Record of Concern/Record of Response for October 27, 2006

To: Richard Levitt
Hydro Project Manager

From: Bob Christensen
Hydro ECM

Summary

Figure 3.1: Elevation model for the area around the Blueberry Hill road cut. Two slides have occurred in this area: one back in July and one in October.

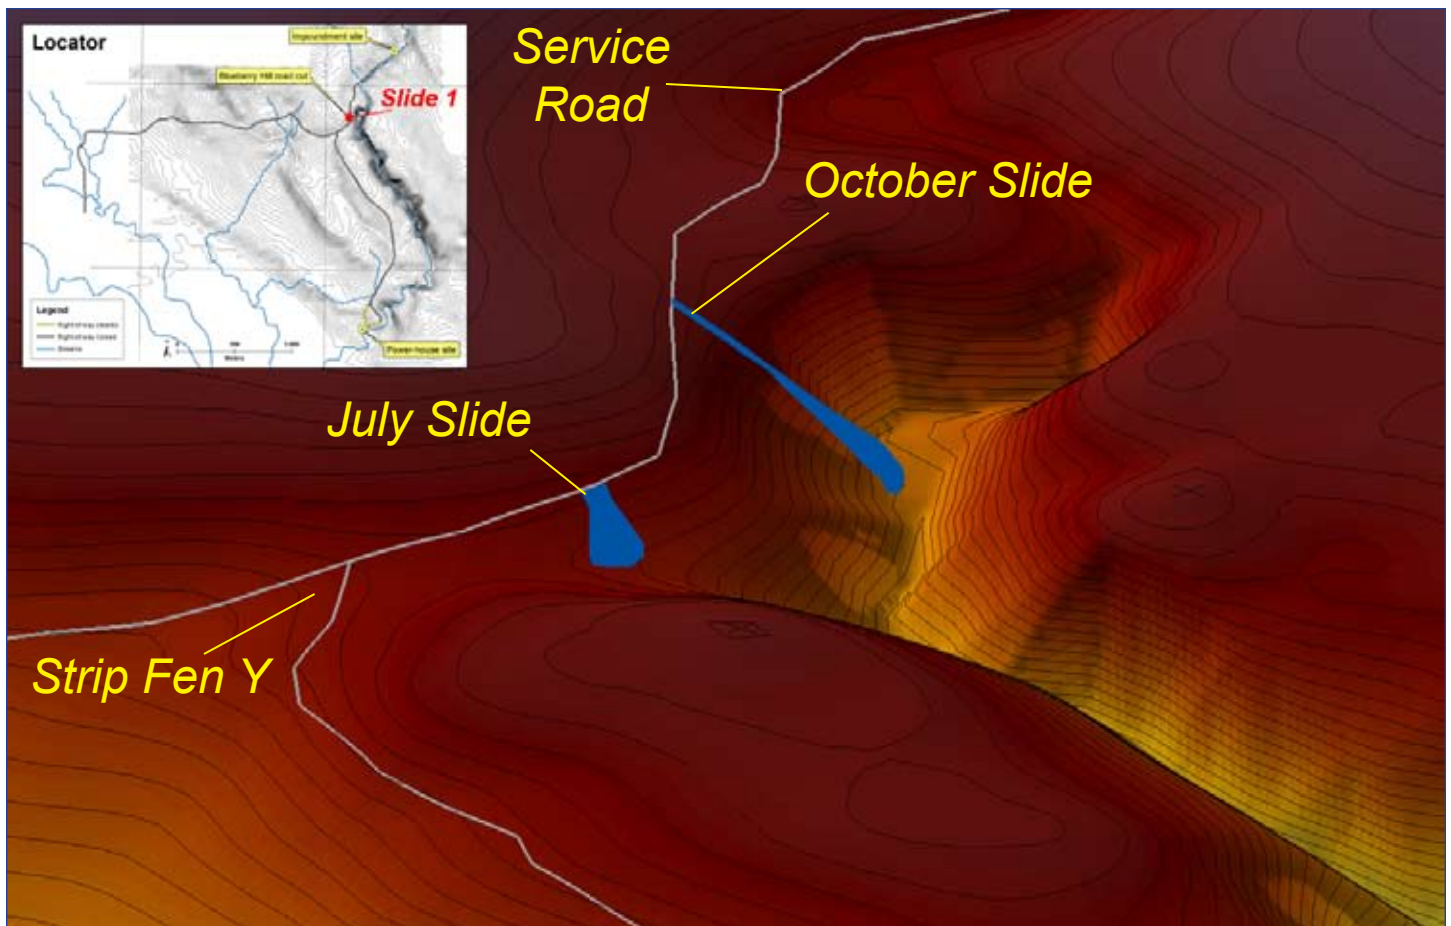
The first slide into the creek occurred at the Blueberry Hill road cut area on October 6th (see figure 3.1). A previous record of concern was filed in July when road construction activities first began in this area (see Appendix 2 of the July report). Part of the record of response from the project manager and construction superintendent was to propose moving the road back from a bench cut at the canyon wall to a trench cut approximately 40 feet from the canyon wall (see figure 1). Vegetation, topsoil and bedrock were not disturbed along the canyon wall leaving a large berm between the blasting of the road and the canyon wall. Avoidance of daylight shooting here appears to have worked well for reducing the likelihood of mass wasting in most of this area, however, it was eventually necessary to daylight out into the neighboring valley in order to continue with the intake road up toward the impoundment.

Slide 1 into the creek resulted in a narrow band of the forested slope giving way immediately below the daylight shot and dumped topsoil, trees and rock from the blast down the ~ 200' canyon walls to Falls Creek (see figures 3.1, 3.2, 3.3, 3.4, 3.5). Turbidity was tracked following the event with a peak of 31 NTUs occurring about an hour after the shot. Immediate impacts to fish habitat were minimal.

The greatest concern I have for this area is that slope disturbance from this slide may lead to further unravelling and sliding of nearby steeply forested habitats. There are potential marbled murrelet nesting trees in this forest and further slide could temporarily dam the creek below and contribute to increased downstream turbidity. No mitigatory actions have occurred thus far. I am currently recommending that work with matting, vegetation and runoff control be done to stabilize and protect the disturbed slope.

Figure 4.1: Elevation model for the area around the powerhouse road cut. Three slides have occurred in this area: one back in August and two in October.

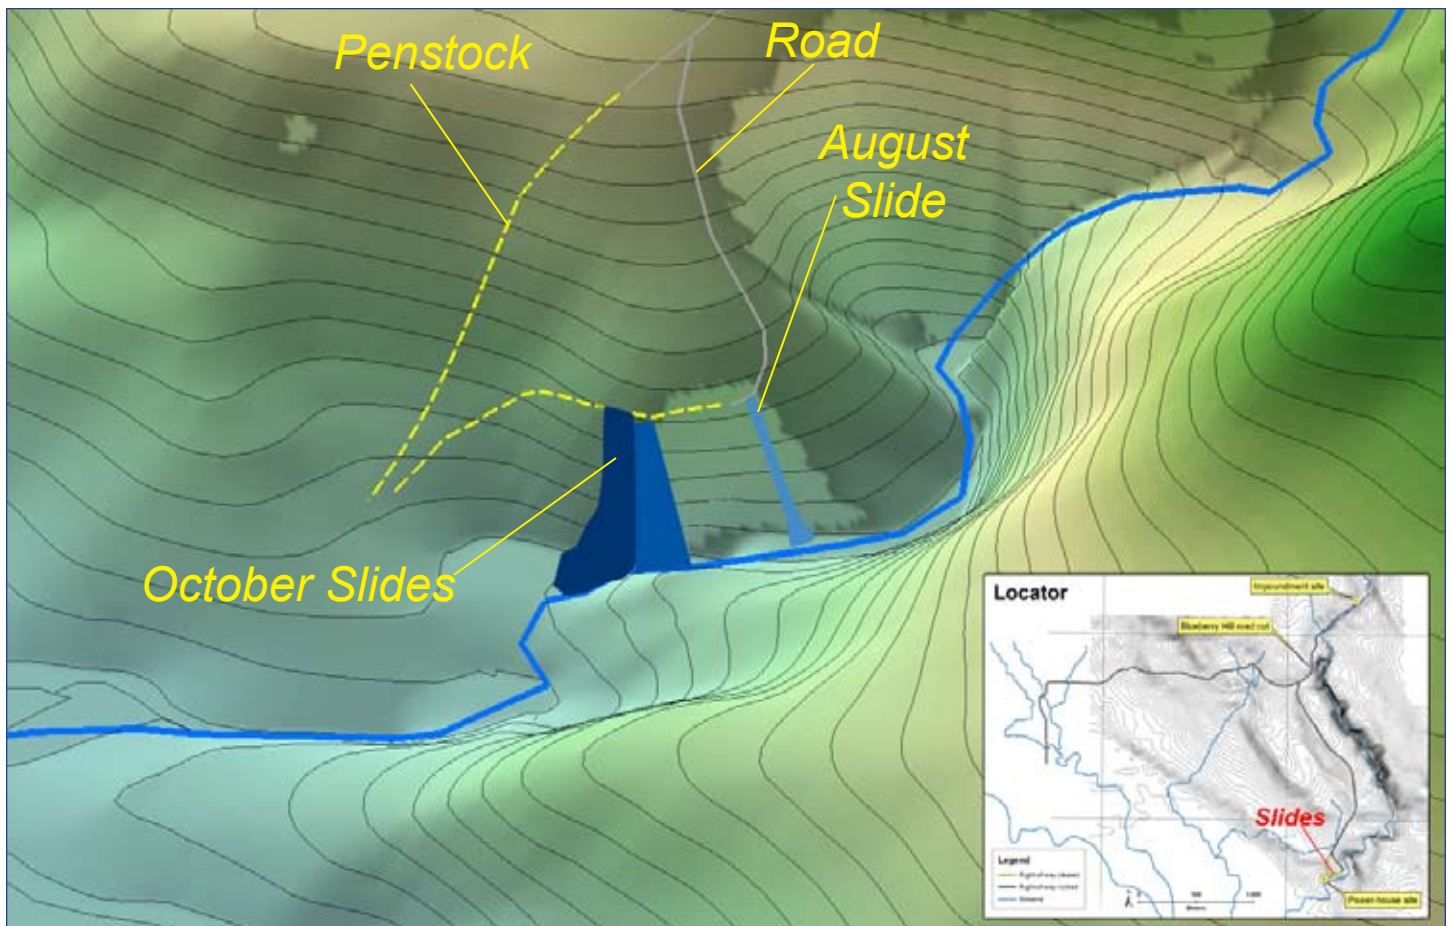
The second slide into the creek occurred at the powerhouse site on October 12th just downstream of the slide reported in September (see figure 4.0, 4.1, 4.2 and 4.3). Though there was a small berm between the shot and the canyon wall the material was largely topsoil and rotten rock and provided little protection of the slope from the blast. This section of the road could have been moved further from the canyon wall after the slide that occurred in September provided a “heads-up” on how unstable this area was but this would have greatly increased the cost of this section of road and would not have guaranteed that no mass wasting would have occurred in this area. Following consultation with the project manager and construction superintendent it was decided that the situation would be handled by modifications of the blasting plan. In particular, the depth of drilling and the amount of explosives used were reduced and lookers were employed for relief.

Slide 2 into the creek resulted in a relatively small amount of topsoil and a few trees entering the creek. Immediate impacts to fish habitat were low with just a small area of potential salmon spawning gravels buried and very little turbidity measured in the aftermath. As with the slide at Blueberry Hill my greatest concern for this area is ***that slope disturbance from this slide may lead to further unravelling and sliding of nearby steeply forested habitats.*** To some degree this concern has been made a moot point because the forested slope downstream of slide 2 was lost as a result of another daylight shot in this area and slide 3 into the creek. No mitigatory actions have occurred thus far. I am currently recommending that work with matting, vegetation and runoff control be done to stabilize and protect the disturbed slope.

Slide 3 into the creek occurred at the powerhouse site on October 19th (see figure 4.0, 4.1, 4.4 and 4.5). Like the slide at Blueberry Hill, this slide also occurred as a result of a daylight shot that was at least partially unavoidable as the road was coming out of the bench cut corner above Falls Creek to descend into the powerhouse valley. Slide 3 occurred in two parts: 3.1) the forested slope immediately between the shot and Falls Creek slid down into the creek, and 3.2) the “topsoil” in the powerhouse valley gave way and slid into the creek when loaded with shot rock. The blasting plan for this area was to lift and throw the rock away from the canyon wall and into the powerhouse valley. The shot went according to the plan but the forested slope was shaken enough to still result in slide 3.1 and the down slope loading of the powerhouse valley unexpectedly resulted in slide 3.2.

Slide 3 into the creek was the largest thus far and resulted in approximately 2,500 yards of topsoil and shot rock covering the creek, as well as several logs and trees. Although potential spawning gravels were not mapped in this location in 2000, recent photos indicate that potential spawning gravels, especially for coho salmon, were likely present in the area now covered by the slide (see Appendix 1 for a figure excerpted from Flory 2000, Resident Dolly Varden, Anadromous Fish Species and Benthic Invertebrates of the Falls Creek Area, part of the PDEA). The impacted area included an island in the center of the stream and a channel along the east side of the island. The terminal lobe of the slide now rests on top of this island and the channel on the east side was completely buried. No mitigatory actions have occurred thus far. Jackie Timothy of the DNR met with me and the project manager on-site to assess impacts and begin a discussion on possible mitigation actions. Plans for mitigation are ongoing and will be described in further detail in a subsequent report.

Although it has not been determined if additional shots will be necessary in preparation of the powerhouse site, it is clear that ground disturbing activities will certainly occur in conjunction with anchoring the penstock and building the foundation of the powerhouse structure. The risk of continued mass wasting in this area will remain high throughout additional construction activities and for an undetermined period of time after the completion of construction. Special care during construction will be necessary to minimize impacts to the stream and risk to construction personnel. Proactive measures will likely be necessary for long-term slope stabilization.

The same concern regarding the potential for mass wasting into Falls Creek exists along the road descending to the powerhouse as existed along the intake road route. Initially, the same precautions were employed on the powerhouse road as were used successfully on the intake road. This included moving the road away from the canyon wall and employing a trench cut rather than a bench cut. It was planned to shoot smaller sections of road to minimize the blast. The blasting plan and timing of charges were to move the rock away from the canyon wall.

In spite of all this, a slide occurred after the first shot. Since the road was moved away from the wall as far as practicable, the size of the shots was further reduced. Eventually, we used 6 shots in the powerhouse road section to blast less than half the road volume that was shot in one blast in the Blueberry Hill area of concern on the intake road. In spite of these precautions, another slide occurred on the 3rd shot.

The last shot, which was to "daylight" the road into the powerhouse "valley", was to contain the lightest load of all the powerhouse shots. The blasting plan was to move the rock forward into the valley. The shot went according to plan, however most of the remaining slope to the creek gave way. The ravine that received most of the rock that was shot forward slid into the creek with the additional weight of the rock.

The rock in the vicinity of the last shot appears to be more degraded than further up the road. The last shot was lightly loaded and was expected to produce larger size rock for riprap. However, the rock produced was the same or smaller shot rock than preceding shots.

The project superintendent was confident that our blasting plan would not cause these slides. However, he was wrong. It is possible that nothing would have prevented this. The same slope had a mass-wasting event last winter, which was a natural event. There is abundant evidence of natural slides occurring frequently in the area.

The rock buffer between the slope and the road (the center line of the road was 40' from the slope), which was to remain intact, was so weakened that it was removed as a danger.

Figure 5.1: Elevation model for the area around the intake road cut and impoundment site. One small slide has occurred here from blasting. The impoundment site will be especially difficult to blast.

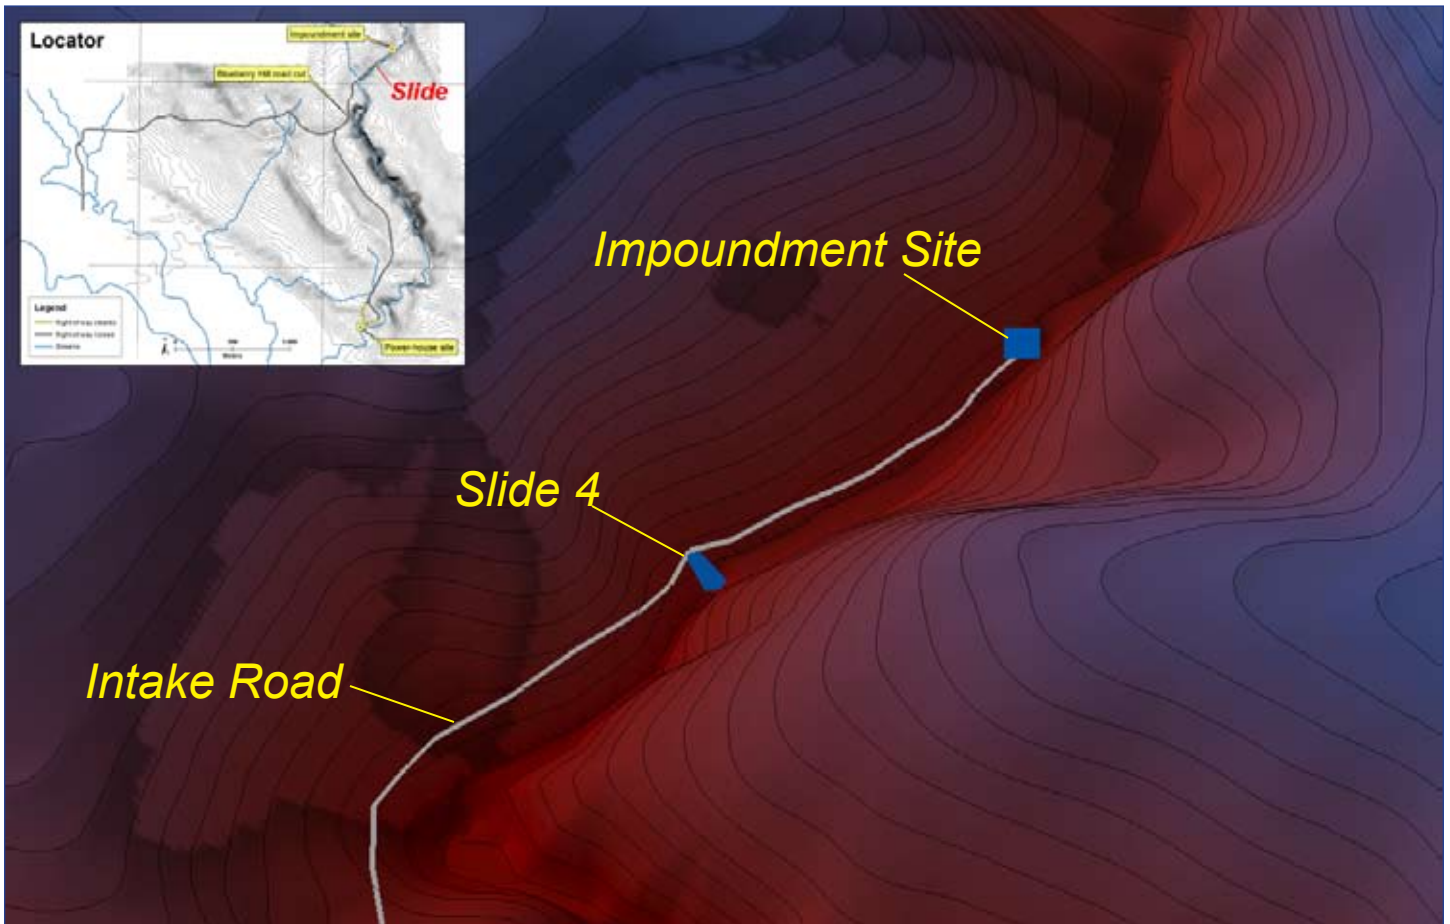
Slide 4 into the creek resulted in a small amount of mud and shot rock sliding ~ 20' down from the intake road into the creek (see figures 5.1 and 5.2). Minor impacts to resident fish habitat occurred as well as a short-term increase in downstream turbidity. Considerable blasting work remains along this stretch of service road and at the impoundment site (see figures 5.1 and 5.3). With the exception of the shot that resulted in slide 4, current blasting plans along the road appear to be working fairly well in keeping side-slope material out of the creek. It is important to keep in mind that blasting in such close proximity to the stream and with such unstable materials on the proximal slopes makes for an extremely challenging working environment for the road builders. This was brought to the attention of FERC on-site during their September visit. That having been said, I am much less concerned with the minor impacts that may result from shooting the creek-side road and penstock grade than I am concerned about the potential for a very large mass wasting event during the development of the impoundment site.

The area around the impoundment site appears very problematic in terms of slope stability (see figures 5.4 and 5.5). The slopes are steep and appear to be covered by a fairly deep layer ~1-20' of clays, mucky gravels and thinly bedded topsoils and vegetation. Evidence of ancient and contemporary mass wasting events is prolific in this area. Mass wasting during and after construction are a highly likely. Considerable effort will be necessary to minimize the impacts future mass wasting in this area.
